MEMORANDUM

To: Jessica Hall and Jennifer Kalt, Humboldt Baykeeper
From: Michael Moule, PE, TE and Magnus Barber
Date: August 6, 2013
Subject: Eureka-Arcata Route 101 Corridor Improvement Project Review

Figure 9C-103 (CA). Example of Bicycle Lane Treatment Through an Interchange

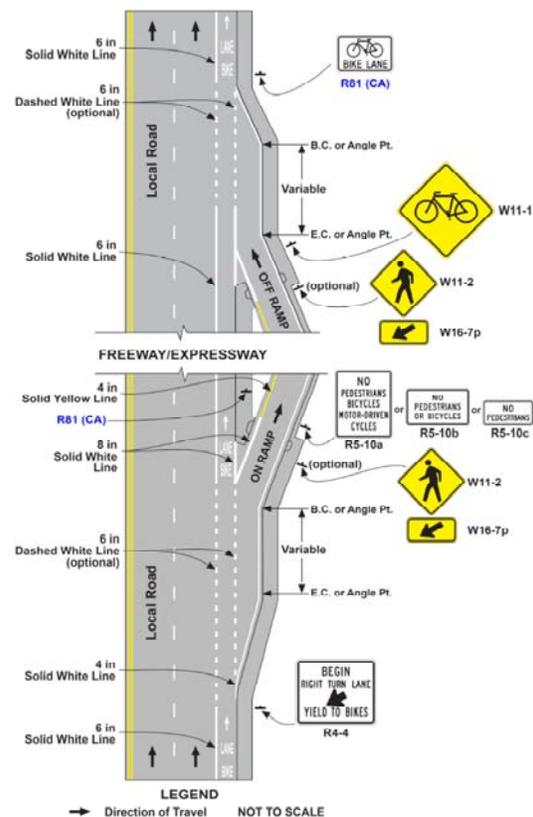
One mitigating solution to the free-flow ramp problem is to provide bike lanes or undesignated shoulder areas between the right turn deceleration lanes and acceleration lanes, as shown in Figure 9C-103 from the California MUTCD, shown at right.

Continuous Green T-intersection

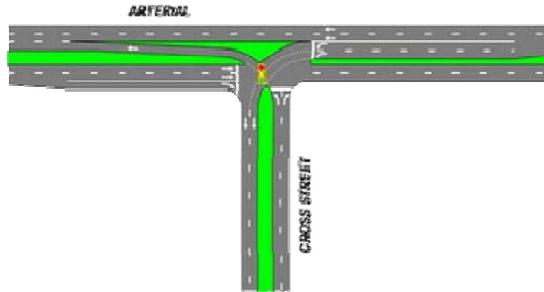
This is an alternative design for signalized intersections, where the traffic along the top of the T intersection (in this case southbound Route 101 traffic) would not be stopped at the signal, but traffic in the other (northbound) direction would be stopped in order to allow left turns to and from the stem of the T. The image at right (from the Maryland State Highway Administration (MDSHA)) shows this design (Route 101 would be the “Arterial” as labeled on this image).

This design has been proposed by Caltrans for Airport Road as Modified Alternative 3A, called a “half signal.” We’ve chosen to use the term “Continuous Green T-intersection” (CGT) since this is what is used by the Federal Highway Administration (FHWA), and “half signal” is more commonly used for a special kind of pedestrian signal. For more information about CGTs, see the case study from FHWA at this link (<http://safety.fhwa.dot.gov/intersection/resources/casestudies/fhwasa09016/>). Our recommendation would be to consider the design of CGTs at Airport Road, Indianola Cutoff, and Bayside Cutoff, with closed medians at the remaining intersections and driveways.

Bowtie Intersection

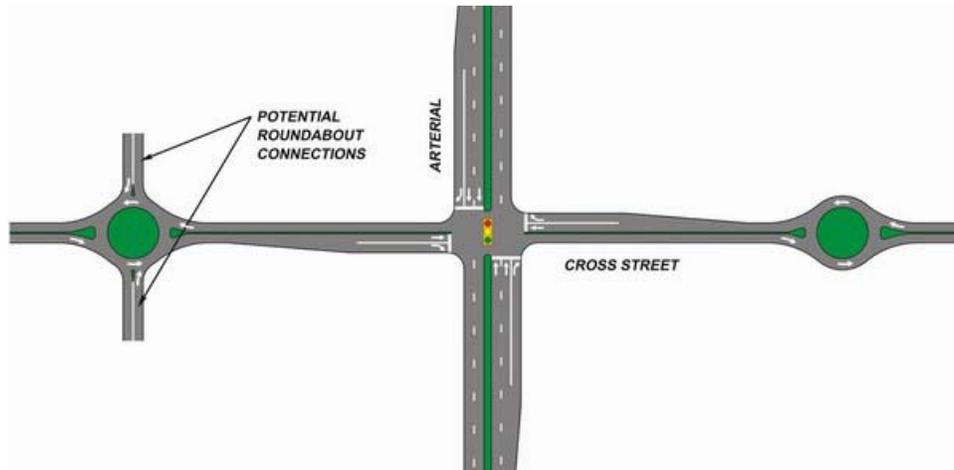
This type of intersection allows for U-turns at a roundabout (or “fake” roundabout) on the cross street. In this case, there would only need to be one roundabout on the east side of Route 101 (only half of the bowtie). The image below from MDSHA illustrates this solution.

At Indianola Cutoff, it is recommended to evaluate the placement of a roundabout at the intersection of Indianola Cutoff and Indianola Road, east of where 101 Slough crosses underneath Indianola Cutoff. It appears that a roundabout with the necessary 130-foot inscribed circle diameter could be built at this location without significant wetland impacts, and minimal right-of-way requirements, probably just on the north side of Indianola Cutoff.

Accounting for U-turns

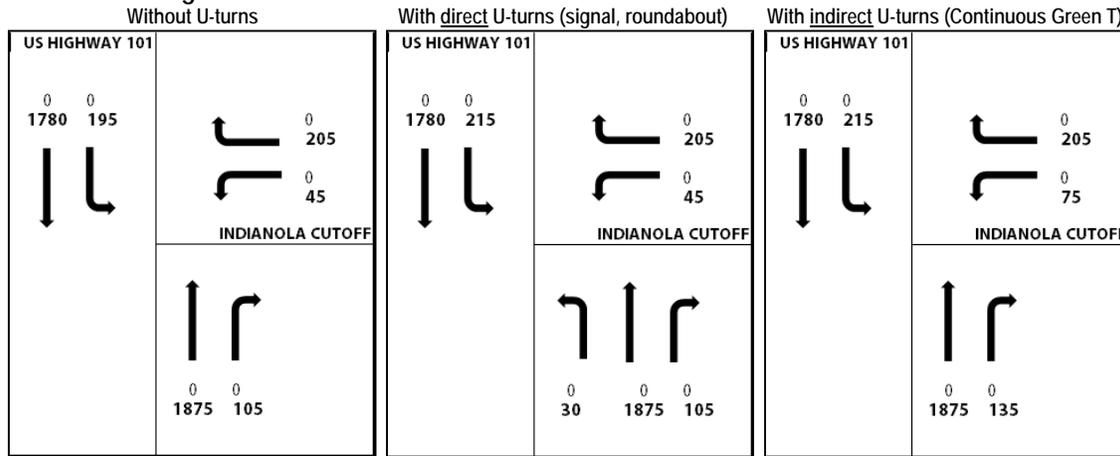
Several of the proposed designs call for closing the median at several intersections and driveways. However, there are properties at these intersections that generate traffic – south of Indianola Cutoff there is a car dealership and a lumber yard, and north of Indianola Cutoff (Bracut) there is

an RV park, bicycle camping, and some industrial uses. With the median closed, people entering or exiting these land uses would need to make U-turns at Indianola. For example, vehicles exiting the car dealership and wishing to turn south would need to first turn north and then make a u-turn at Indianola. For the purposes of this analysis, we assumed that Airport Road and Bayside Cutoff would also be signalized or have roundabouts, allowing left turn and U-turn movements. So no U-turn volumes from these intersections were included in the analysis at Indianola Cutoff.

For the signalized and roundabout alternatives, direct U-turns are possible, resulting in the turning movement counts shown in the middle image below. For the Continuous Green T-intersection alternative, only indirect u-turns would be permitted for northbound to southbound U-turns. That is, first turning right onto Indianola Cutoff, then making the u-turn there, and then turning left back onto 101. We consulted the ITE Trip Generation manual for the land uses at the minor intersections in question, and determined that *at most* these land uses would add 30 northbound U-turns (i.e. 30 right turns and 30 westbound left turns for the CGT alternative), and 20 southbound U-turns.
